SPARANO + MOONEY ARCHITECTURE

ADDENDUM #2

PROJECT:	Caine Lyric Theatre – Fly Loft and Stage Improvements Project	PROJECT NO.	C001541
OWNER:	Utah State University 6550 Old Main Hill Logan, UT 84322-6605	Phone: 435.797.3771 Contact: Thomas Graham	
ARCHITECT:	Sparano + Mooney Architecture 57 West 2100 S Salt Lake City, Utah 84115	Phone: 801.746.0234 Contact: Seth Striefel	
DATE OF ISSUANCE:	April 16, 2025

ROOF DEMOLITION PLANS

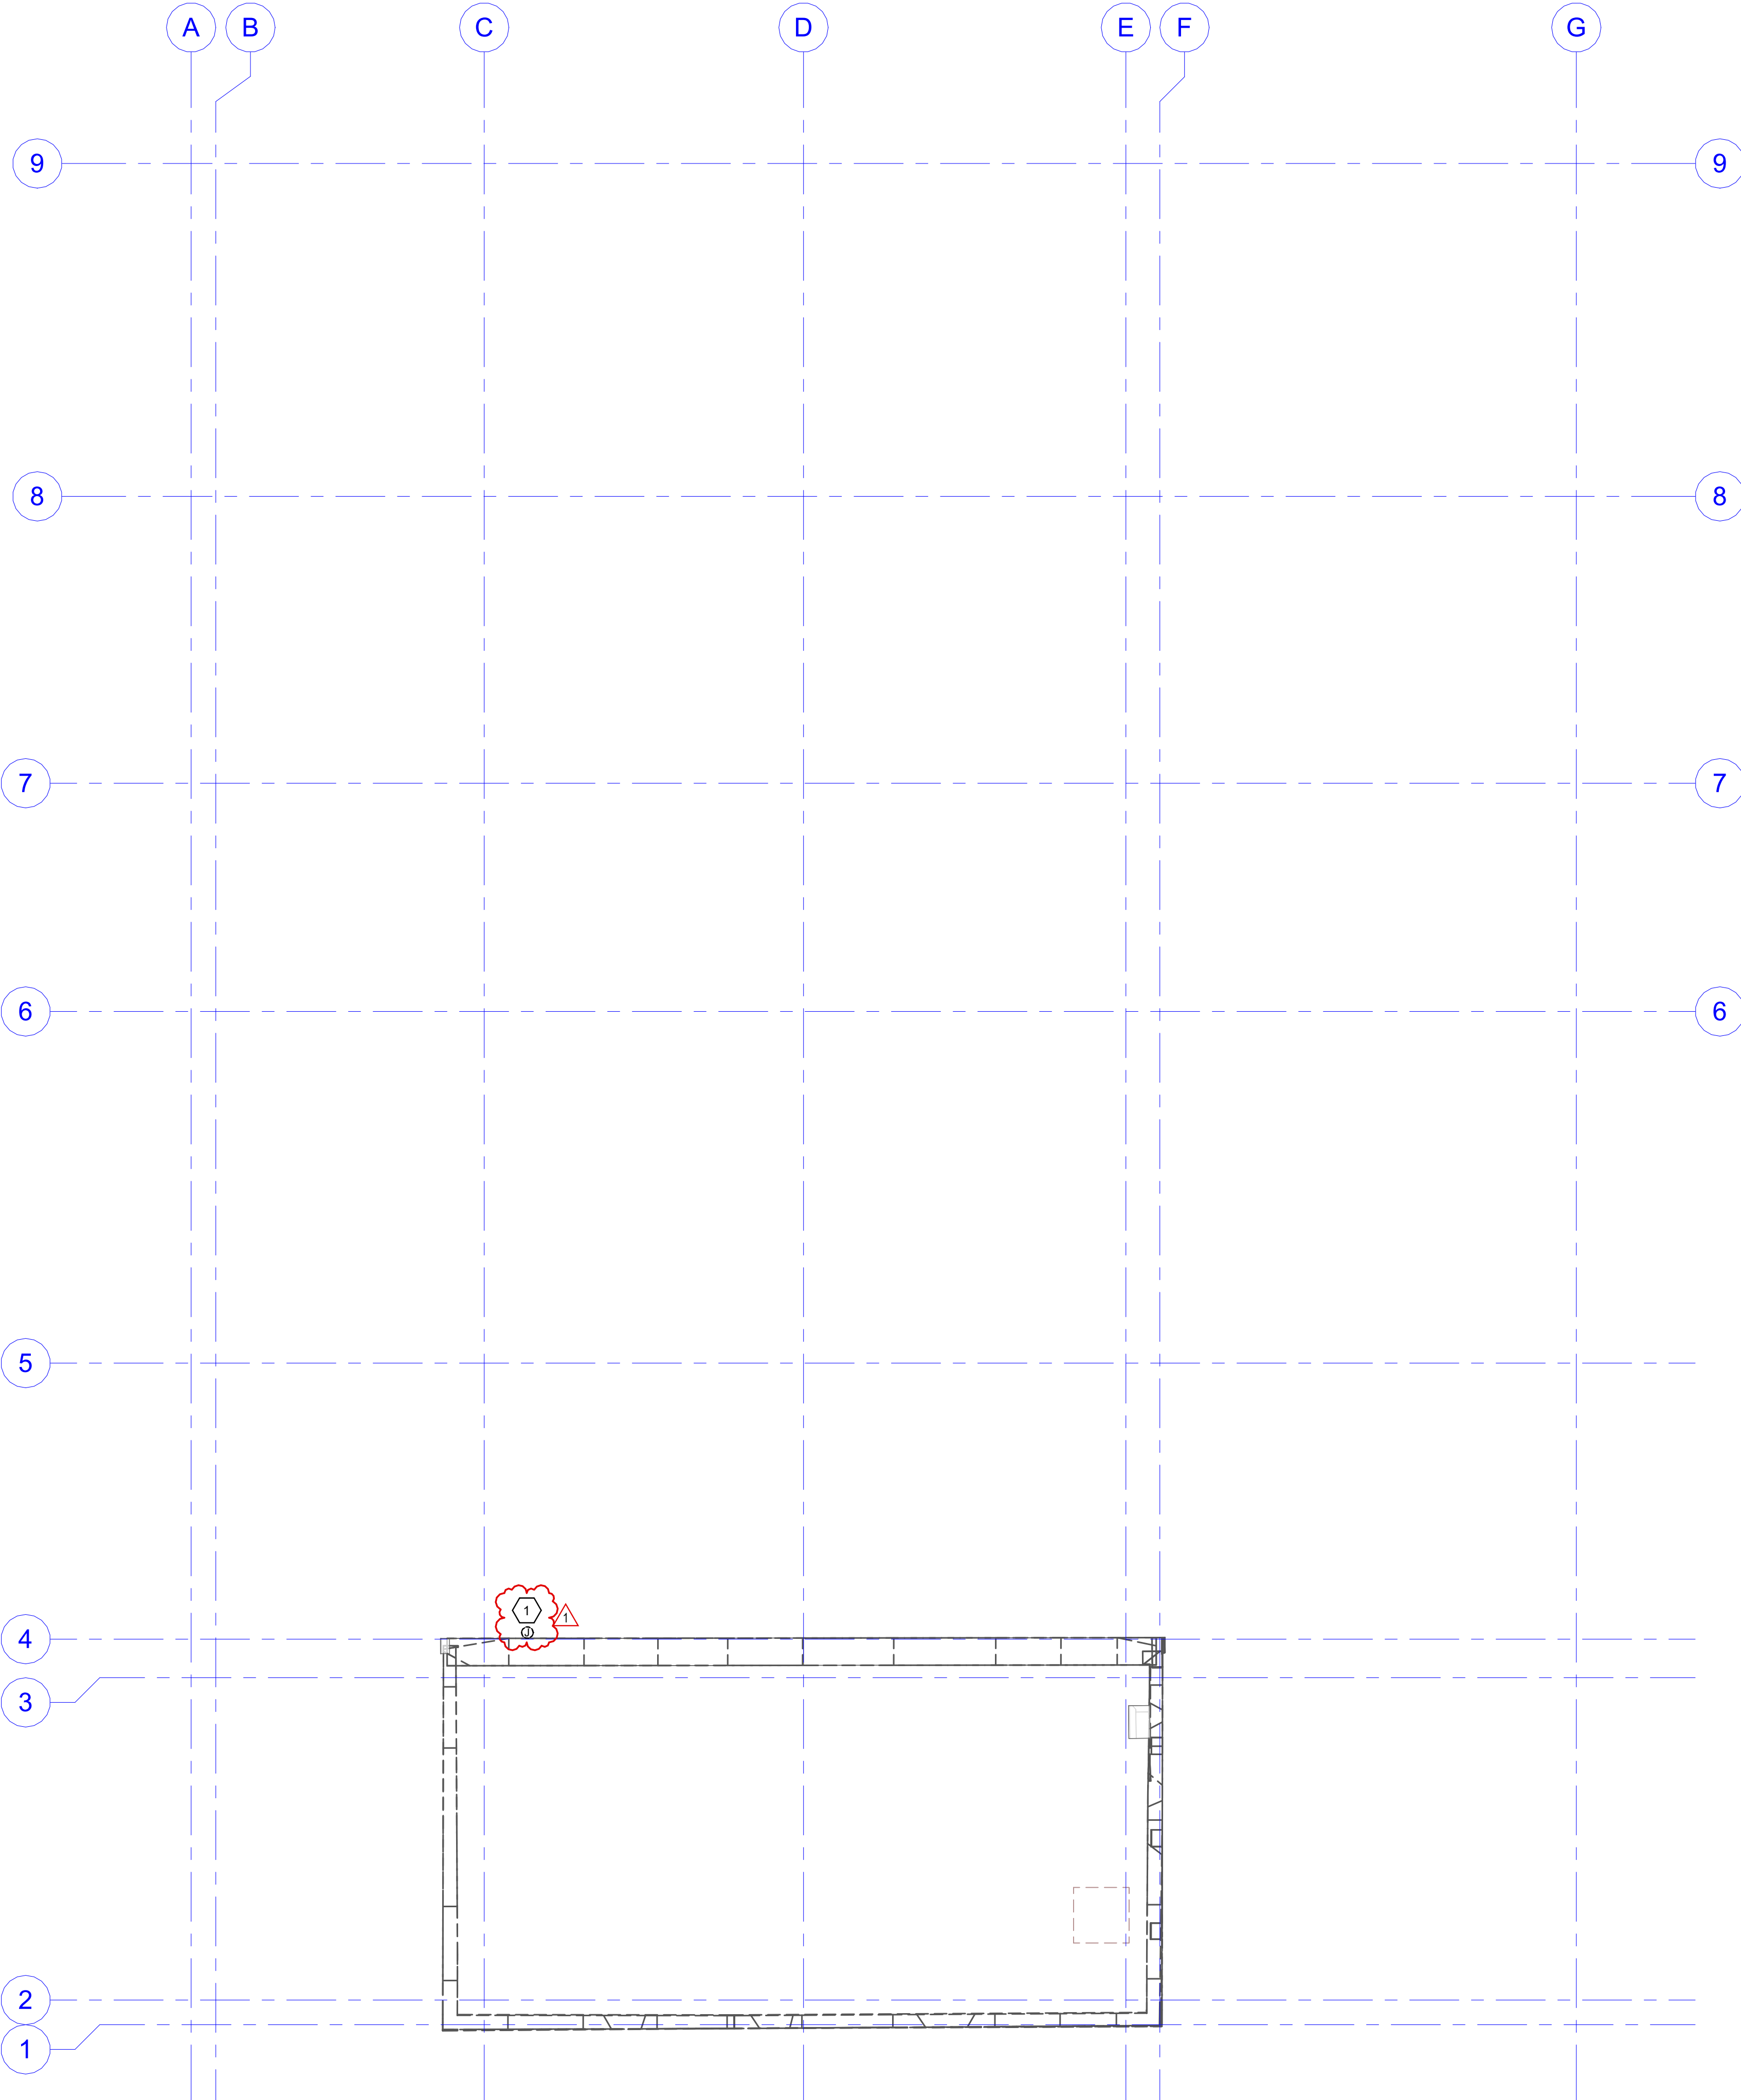
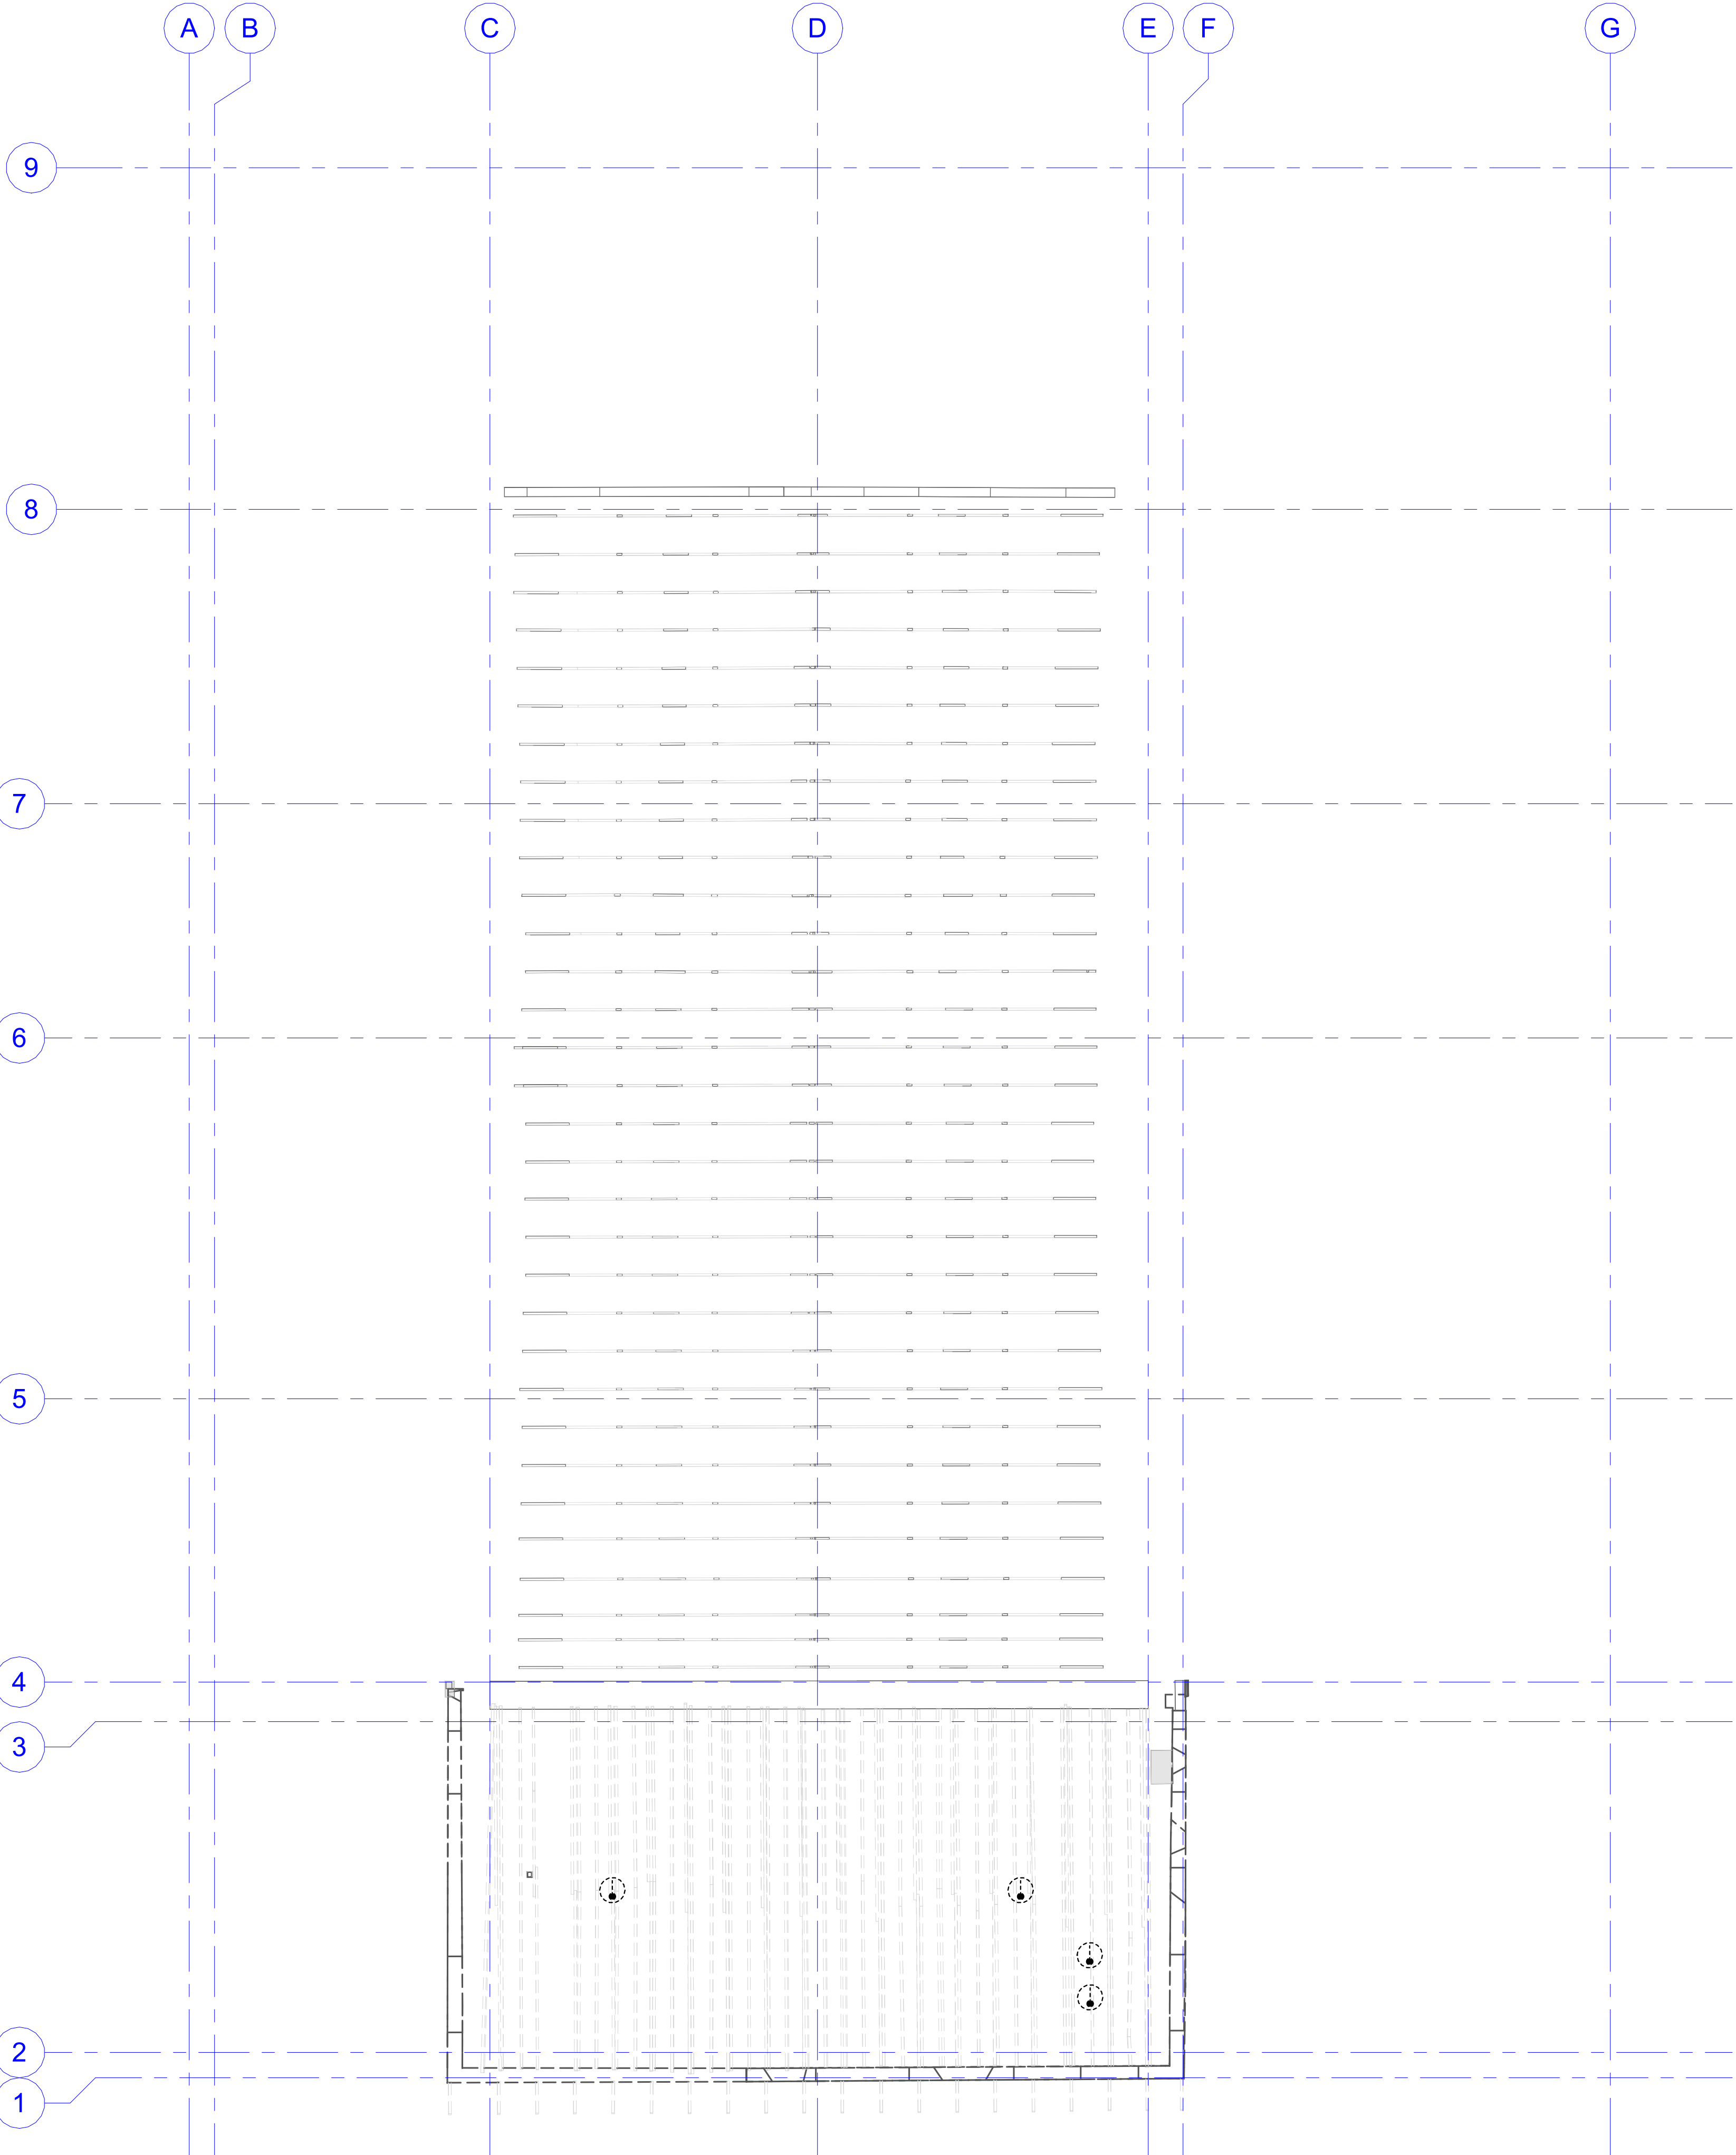
1. ES101 – Relocated pull box “PB1”. See attached sheet.
2. ED101 – Revised sheet keyed note #4. See attached sheet.
3. ED104 – Added j-box for demolition on roof. See attached sheet.
4. ED301 – Revised notes on Existing South Exterior Wall Elevation View3. See attached sheet.
5. EP103 – See attached sheet for the following:
 - a. Added sheet keynote #2.
 - b. Added junction box for IT network.
6. EP651 – Revised Telecom Conduit Riser Diagram. See attached sheet.
